**Subject: MHI's Amended Responses to US-APWR DCD RAI No. 939-6334 Revision 3 (SRP 03.07.01) and No. 940-6532 Revision 3 (SRP 03.07.01)**

Amended Response to Request for Additional Information  
No. 939-6334 Revision 3

**RAI NO.:** NO. 939-6334, REVISION 3  
**SRP SECTION:** 03.07.01 – Seismic Design Parameters  
**APPLICATION SECTION:** 3.7.1  
**DATE OF RAI ISSUE:** 06/12/12

Figure 1, Comparison of Median Estimates for Strain Compatible Properties (shear-wave velocity, compressional-wave velocity, shear-wave damping, compressional-wave damping) Developed for 60 and 30 Realizations for 500 ft Deep Profile 560-500

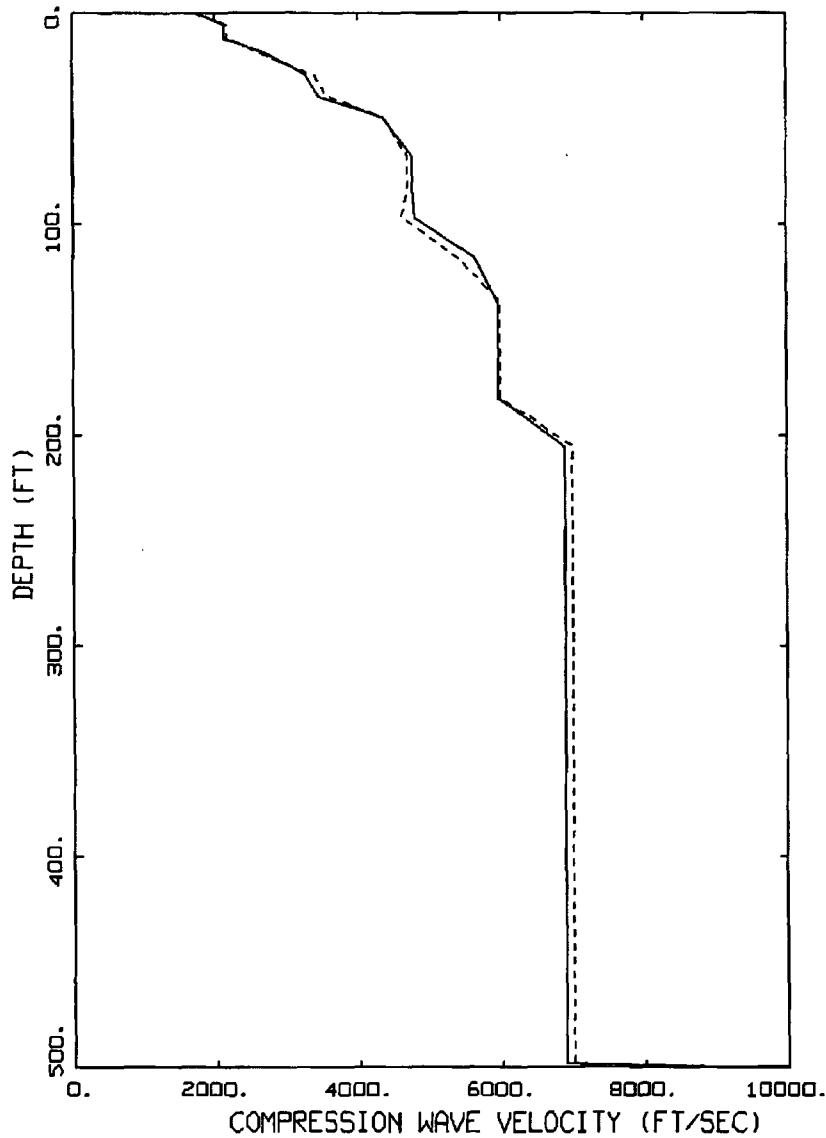
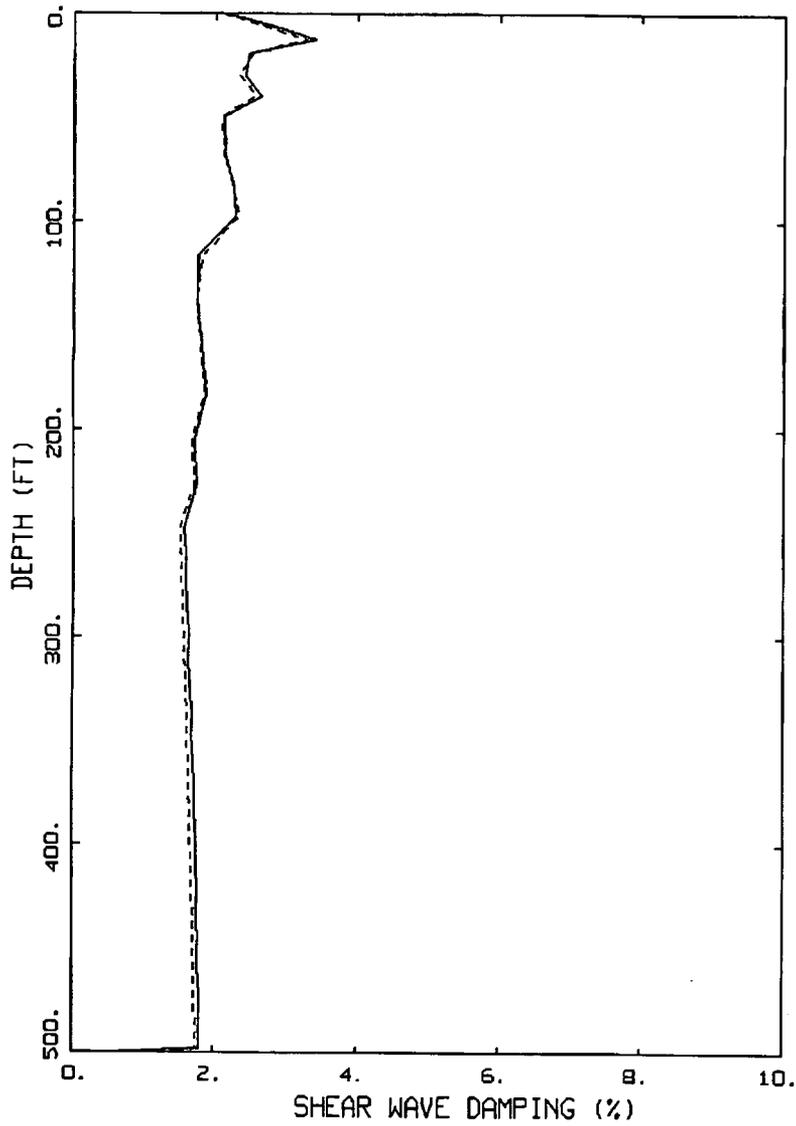
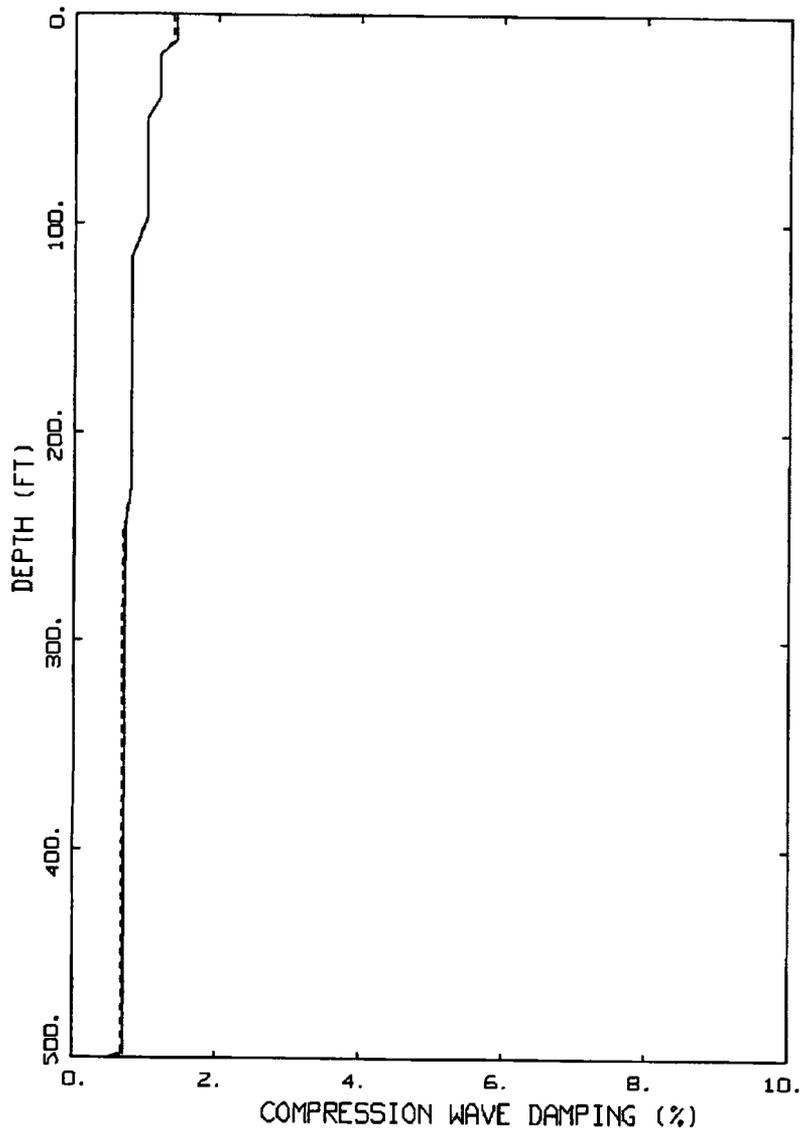
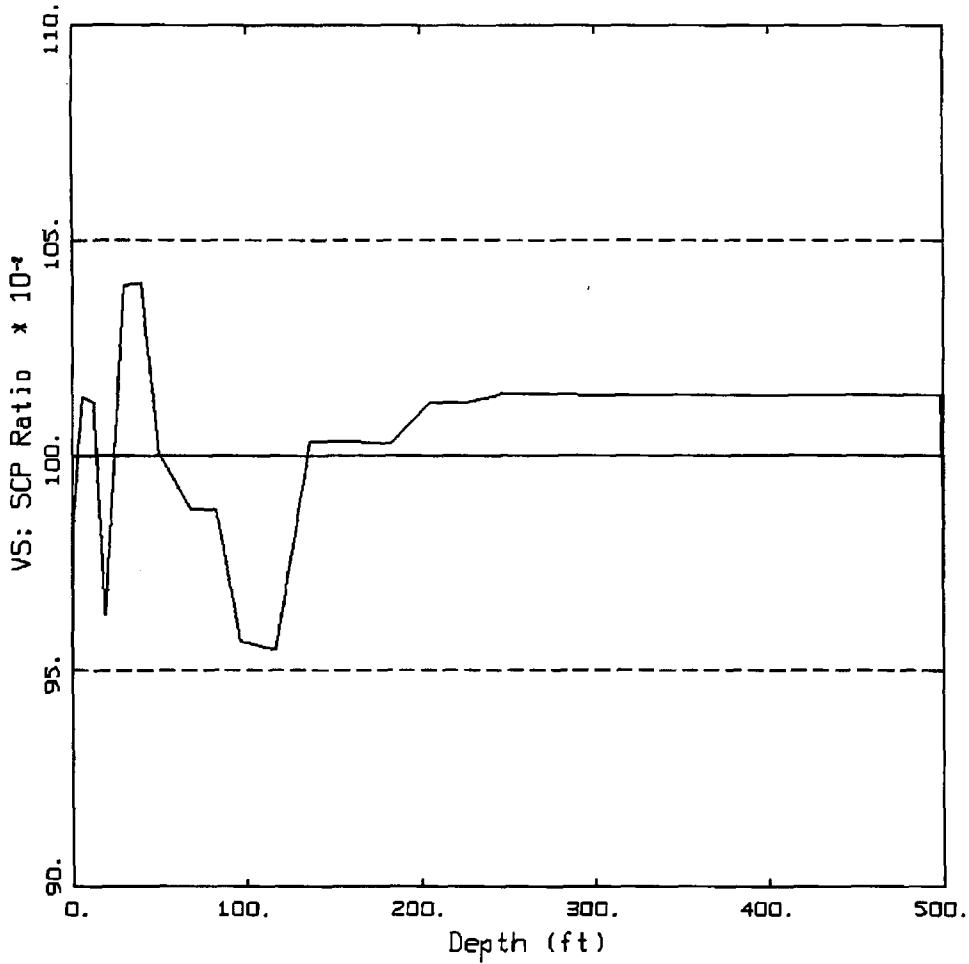
In its response to RAI 850-6002, Question No. 03.07.01-22, the applicant provides Table 1 which is taken from a source of standard statistical tables. Table 1 shows the sample size required for a given percent error in the standard deviation for a normal distribution, which the applicant purports to support their assertion that using 30 realizations in the analyses provides sufficient stable estimates of means and standard deviations. Further, the applicant states that increasing the sample size to 60 realizations reflects, at best, only an unnecessary and marginal improvement.

The staff considers that the evidence provided in Table 1 to be inadequate for supporting the applicant's argument. The staff is requesting that the applicant use actual data generated from the soil profiles in the US-APWR DCD; provide a table that shows conclusively the convergence as the number of realizations is increased; and provide the rationale to support the claim that 30 realizations instead of 60 realizations as specified in RG. 1.208 is adequate for the analyses.

MHI's position is that increasing the sample size from 30 to 60 reflects a marginal improvement to the accuracy of the strain compatible properties that are developed as median value of the results obtained from site response analyses of 30 realizations.. In order to illustrate the numerical stability in strain compatible properties between 30 and 60 realizations, Figure 1 compares median strain compatible property estimates computed for the two sample sizes for the deep (500 ft) generic profile 560 - 500. Figure 2 provides ratios of the property estimates, i.e., 30 realizations/60 realizations for all properties (shear-wave and compressional-wave velocities and corresponding damping). The maximum difference is about 5% and occurs over shallow and narrow depth ranges. Over the deeper portion of the profile, beyond a depth of about 150 ft, the difference is about 2% in shear-wave and compressional-wave velocity and about 4% in shear-wave damping.

As illustrated in the figures below, there are marginal improvements in increasing the sample size from 30 to 60. Therefore using 30 realizations is sufficient to provide reasonable estimates for the mean generic strain compatible properties used as input for the site-independent soil-structure interaction (SSI) analyses.

**Figure 1, Design Acceleration Time History (Northridge) – X Component (H1, North-South) Developed using SRP 3.7.1, Option 1, Approach 1**

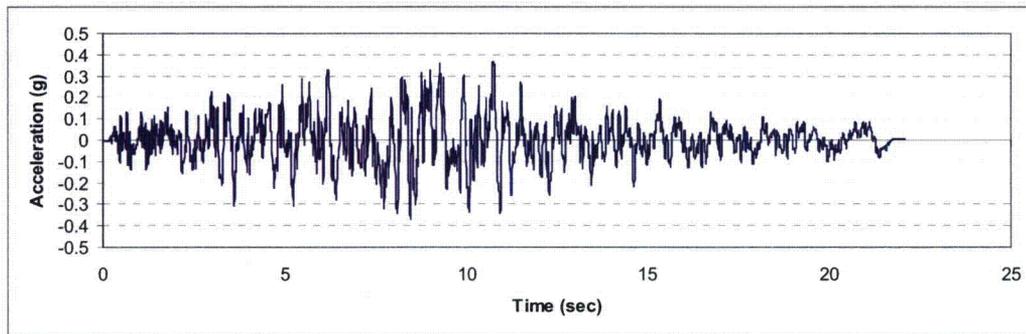
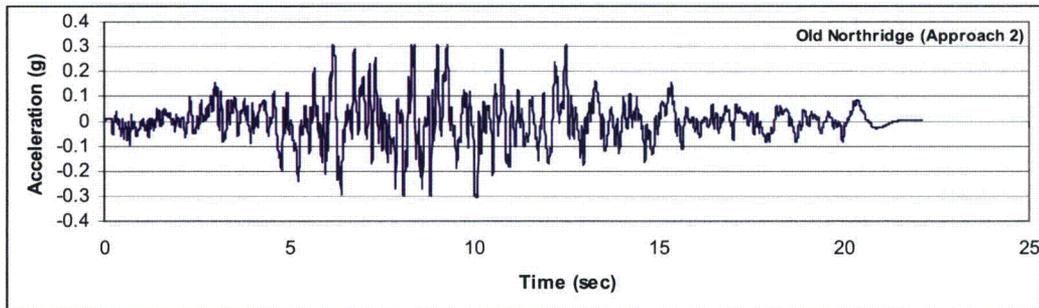
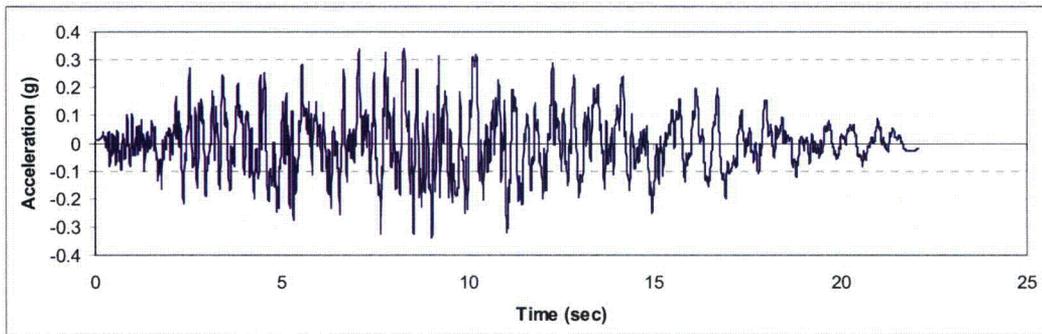
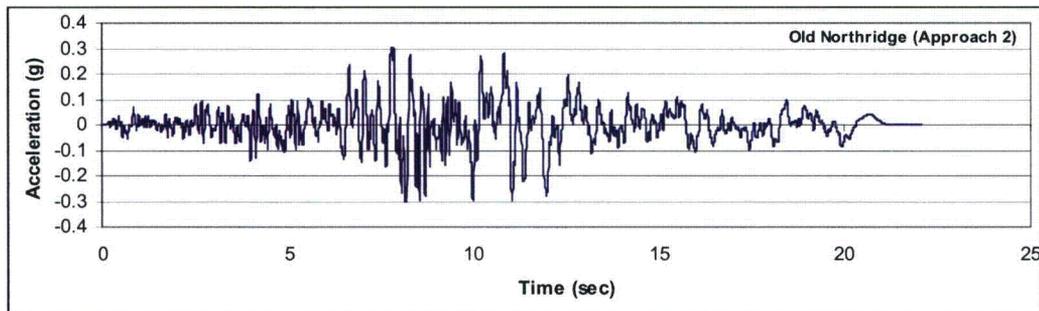
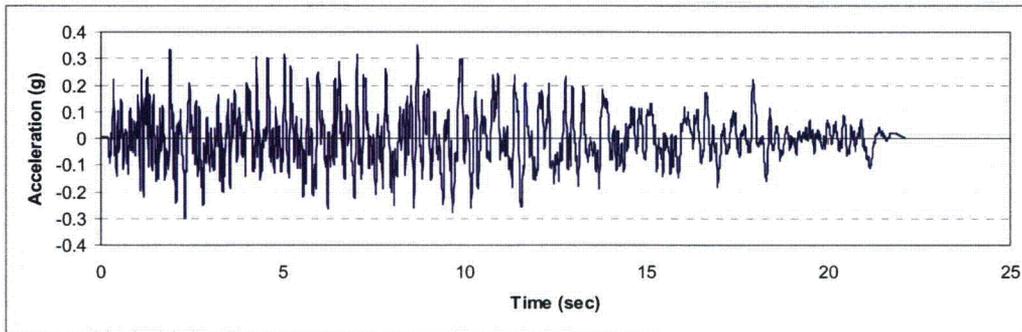
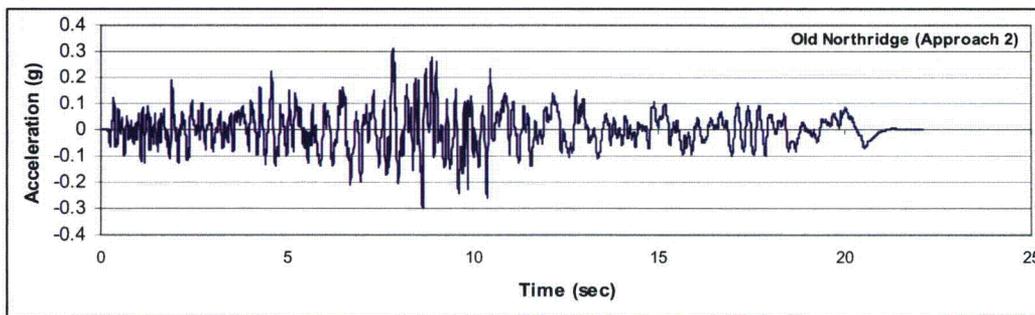
In its response to RAI No.886-6202 Revision 3, Question No. RAI 03.07.01-33, MHI provided digitized acceleration versus time traces for the current design-basis Northridge Earthquake seed records and for the synthetic acceleration time histories developed from the seed records to match the CSDRS. The staff has conducted independent numerical analysis using this information, to evaluate whether the developed synthetic time histories provide an acceptable match to the CSDRS, in accordance with the assessment procedures detailed in SRP 3.7.1.

The applicant has specified that SRP 3.7.1, Option 1, Approach 2, criteria are satisfied. However, the staff has determined that Option 1, Approach 2, is not specifically applicable to site-independent CSDRS based on the RG 1.60 spectra. The acceptance criteria in Option 1, Approach 2, are not appropriate for site-independent CSDRS; rather it is applicable for developing synthetic time histories to match a site-specific uniform hazard response spectrum (UHRS).

- (1) In performing the spectral matching, demonstrate that for all three directions of the CSDRS, the Option 1, Approach 1, criteria are met for 2%, 3%, 5%, 7%, and 10% damping, or justify an alternate damping range based on the values used in the design basis seismic response analysis of SSCs.
- (2) In performing the PSD match,
  - (a) develop target PSDs representative of each of the three directions the CSDRS, which are the stretched RG 1.60 spectra;
  - (b) provide the details of the method employed to develop the target PSDs; and
  - (c) describe the method and assumptions used to generate the PSDs for the synthetic time histories.

MHI has revised the time history methodology used to develop the time history for structural design and in-structure response spectra (ISRS) development to satisfy the SRP 3.7.1 Option 1, Approach 1 criteria. (The terminology used here for time history refers to all three components, i.e., North South, East West and vertical.) The design basis time history in Technical Report MUAP-10006, Rev. 3 is being developed to satisfy the spectral matching criteria and power spectral density (PSD) matching criteria of the SRP 3.7.1, Option 1, Approach 1. The details of how the SRP guidance criteria are satisfied and the resulting time history data are presented below:

The Modified Northridge time histories were redeveloped according to the provisions of SRP 3.7.1 Option 1, Approach 1 (Reference 1), at 2%, 3%, 5%, 7%, and 10% damping. As requested in our June 21, 2012 meeting, Figures 1 through 6 compare the current modified Northridge time histories with the previous modified Northridge time histories, which were developed using Option 1, Approach 2 criteria. Figures 7 through 12 depict the response spectra of the modified Northridge time histories developed in accordance with SRP 3.7.1 Option 1, Approach 1.
